Project	IEEE 802.16 Broadband Wireless Access Working Group < http://ieee802.org/16 >	
Title	MBS Refinement	
Date Submitted	2005-05-03	
Source(s)	Yeongmoon Son, Hyunjeong Kang, Jungje Son, Panyuh Joo Samsung Electronics Co. Ltd. Yongjoo Tcha, Seong-Choon Lee KT Corp. Yigal Eliaspur Intel Corp.	Voice: +82-31-279-5845 FAX: : +82-31-279-5130 ym1004.son@samsung.com yjtcha@kt.co.kr yigal.eliaspur@intel.com
Re:	IEEE P802.16e/D7-2004	
Abstract	This contribution proposes Enhancement and Clarification of MBS	
Purpose	Discuss and adopt this contribution	
Notice	This document has been prepared to assist IEEE 802.16. It is offered as a basis for discussion and is not binding on the contributing individual(s) or organization(s). The material in this document is subject to change in form and content after further study. The contributor(s) reserve(s) the right to add, amend or withdraw material contained herein.

Refinement of MBS

Figure 1. ~~Example of DSA procedure~~ ~~Dynamic Service Addition procedures by MS initiation~~ for ~~multiple several~~ MBS services

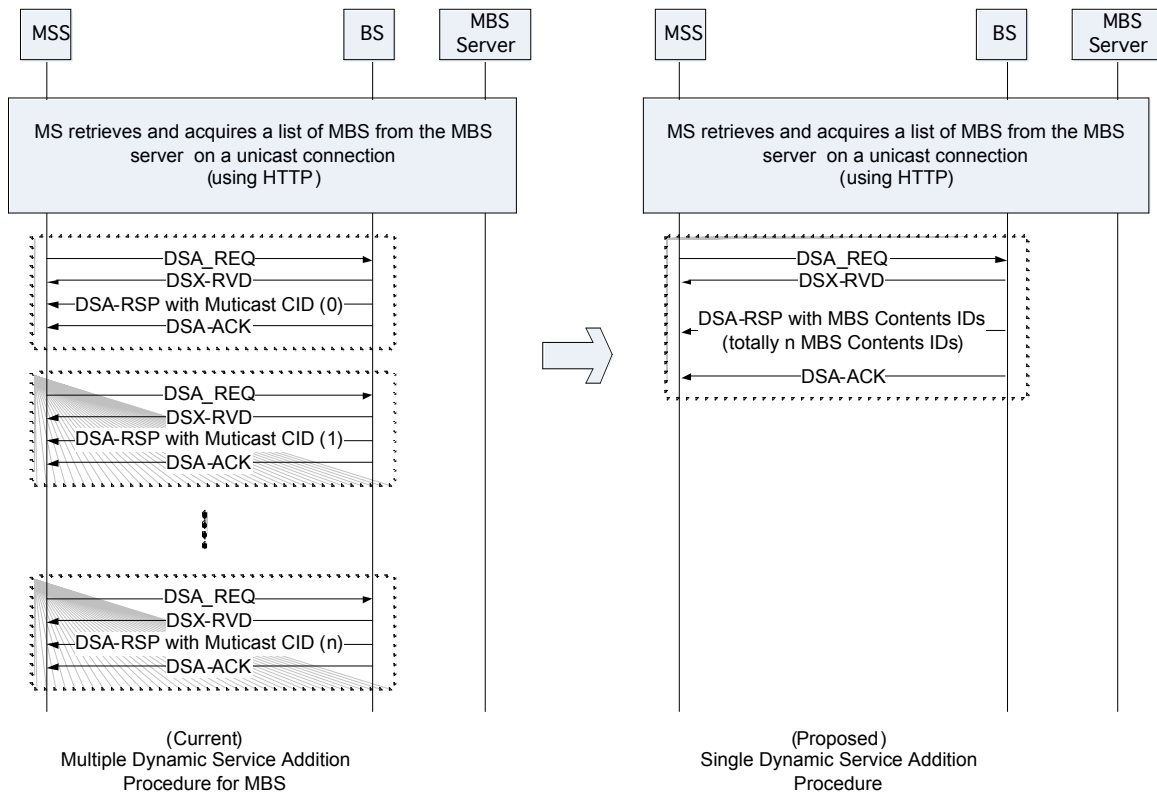
In Multicast and Broadcast Service (i.e. MBS) of IEEE802.16e, when MS is registered to certain BS, it shall perform a Dynamic Service Addition (DSA) Procedure as described in 6.3.13.1 in order to get service of MBS from the BS. And according to current MBS scheme, each MBS contents(or channel) shall have a different connection identifier. Therefore, if MS wants to receive several MBS services from BS, it shall perform DSA procedures as many times as the number of MBS contents which MS wish to receive, as shown in the left side of figure 1. It can cause inefficient bandwidth consuming due to the multiple DSA procedure and the long time for complete establishment of MBS services. But in many cases, since MBS contents may not have different service characteristics, if we have a identifier for each service in same service flow, we do not need to use ~~a~~ different identifier such as connection identifier and service flow identifier.

We propose the 'logical channel ID' used to distinguish each MBS contents which have the same service flow. A logical channel ID is allocated to MBS contents in order by MBS Contents Identifier TLV encoding included in DSA-RSP message. We also propose the new MBS_DATA_IE which includes the logical channel ID.
